SUMMARISED RESPONSE TO RYDE COUNCILS 2ND SUBMISSION TO DPE

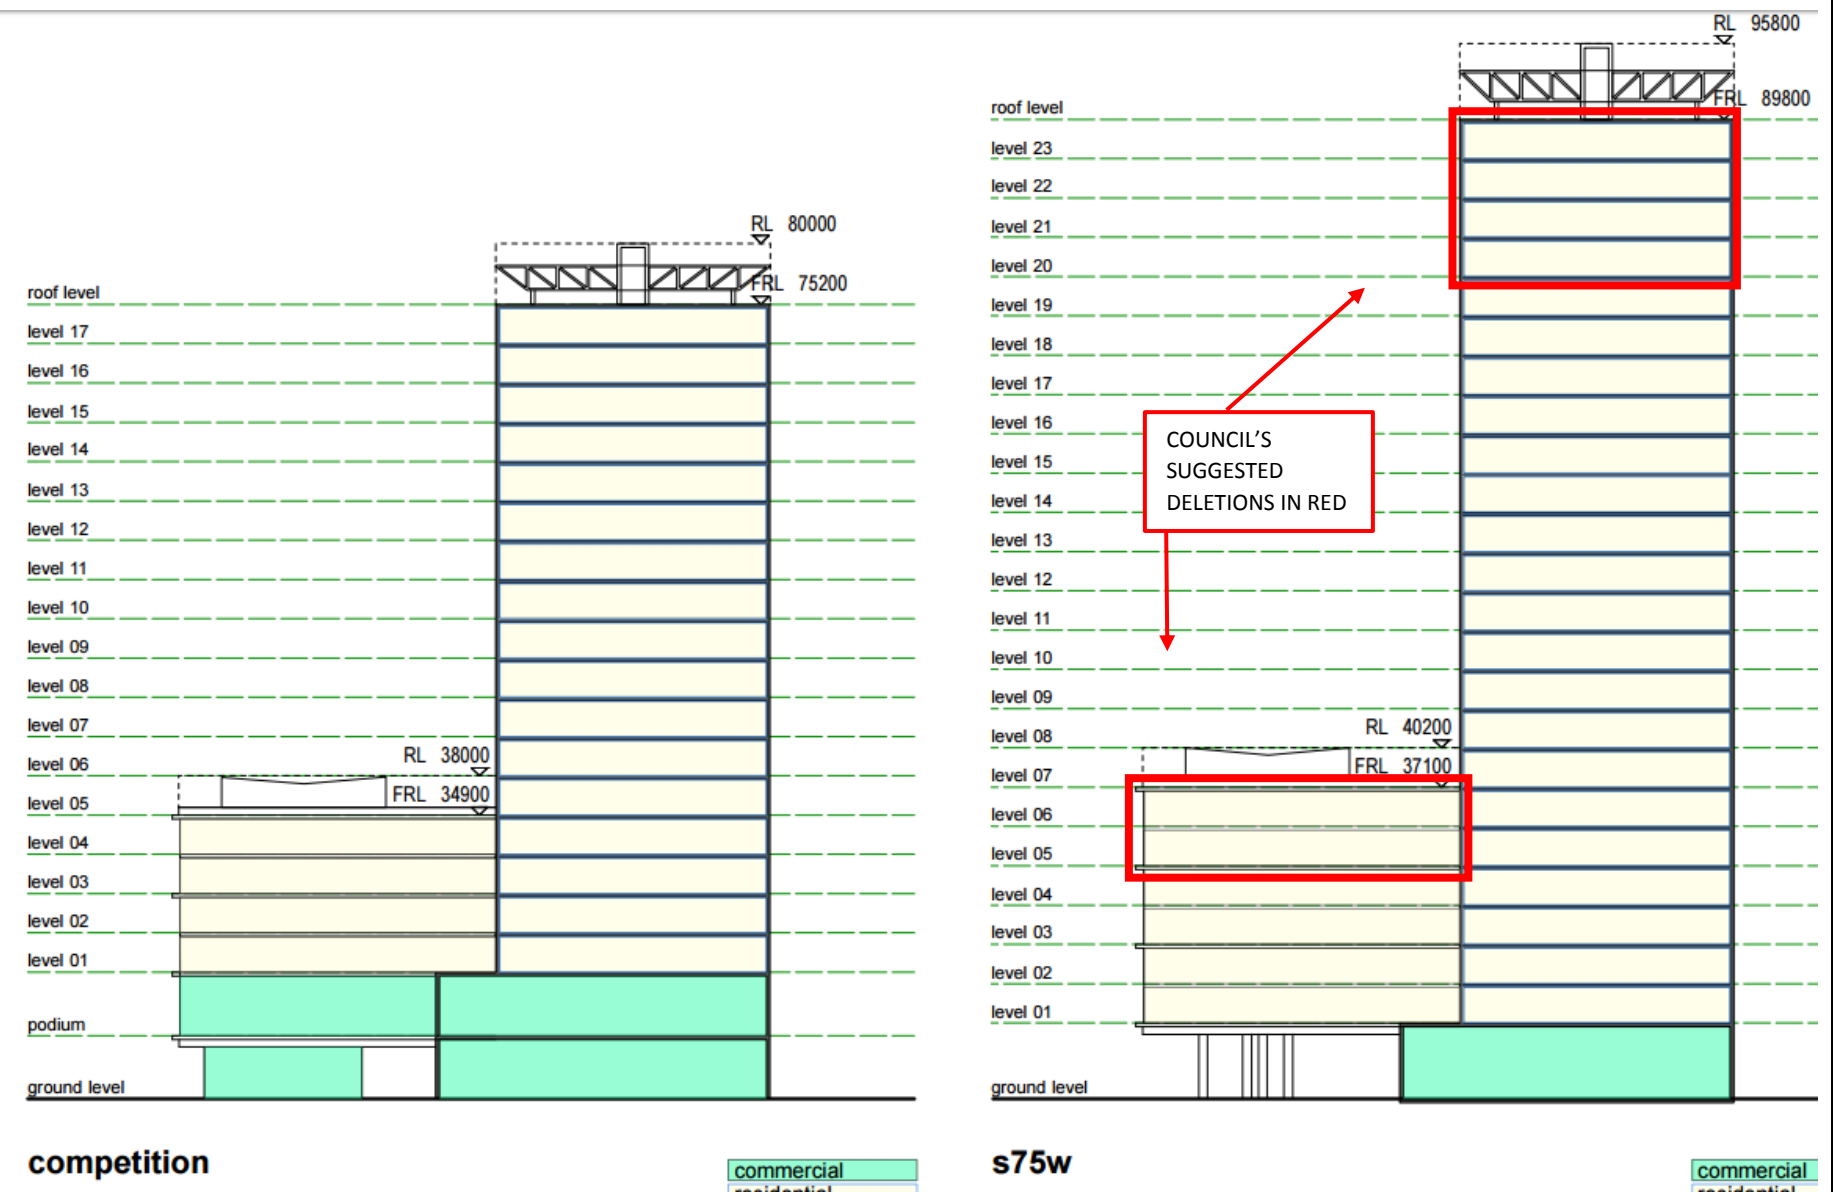
Amend the maximum number of storeys in Stage A to be consistent with the Competition winning scheme i.e. a 19 storey tower and 4 storey podium.

There appears to be confusion in the use of the term 'storeys' for the purposes of the competition winning scheme and the scheme proposed as part of the current S75W application. As can be seen in the section diagram below, the roof RL of the 'podium' building in the competition winning scheme is RL 34.9, whilst the podium building's roof proposed as part of this S75W application is RL 37.1 – 2.2m difference. The tower element for the competition winning scheme, excluding the exoskeleton roof feature, was RL 75.2m. The RL for the tower component in the S75W application, excluding the exoskeleton roof feature, is RL 89.8m – a difference of 14.6m (or approximately 4 residential levels).

NOTE: The current modification application proposes envelope heights as follows:

- Tower building – RL 95.8m
- Podium building – RL 40.2m

Council wishes to reduce the podium by 2 levels, below the design excellence competition winning scheme. Holdmark are willing to consider this outcome on the basis that the total increase in the height of the tower, as proposed in the modification application, is accepted. It should be noted that the DIP has already endorsed both the podium and tower heights (NOTE: Holdmark's VPA offer is affected if heights are reduced).
Page 5 of Councils submission Amend the maximum number of storeys for Stage 9 (café) building adjoining 146 Bowden St to 1 storey.	Holdmark would accept reverting back to the Concept Approval, as modified, in relation to Stage 9, on the basis Council accepts a \$3.5 million monetary contribution in lieu of the community facility forming part of a VPA for Stage A, AND all of the modifications proposed to Stage 2/3 in the current modification application are approved.
Page 5 of Councils submission Insert a new condition with respect to community benefit to require that an agreement is entered into with Council with respect to Stage A (similar to that contained within the Royal Ryde Rehabilitation Centre Concept Consent Instrument MP.05_0001) as follows: Prior to the lodgement of a Development Application for Stage A a planning agreement between the proponent and Council, pursuant to Sections 93F to 93L and Sections 94A to 94E of the Act shall be formalised to provide the following measures: <ul style="list-style-type: none"> Community facilities. Affordable Housing. Public domain and pedestrian infrastructure upgrades. Traffic mitigation measures. 	The proponent prefers that any monetary contributions, WIKs or the like, are specified as a condition of any modified Concept Approval. This is because VPAs are voluntary and another administration at Council may refuse to enter into the agreement. Nevertheless, if Council formally agrees to the existing VPA offers, Holdmark would accept these as a condition of any modified Concept Approval, provided the proponent has the opportunity to review the draft conditions of consent before any recommendation is made to the Planning Assessment Commission (PAC)
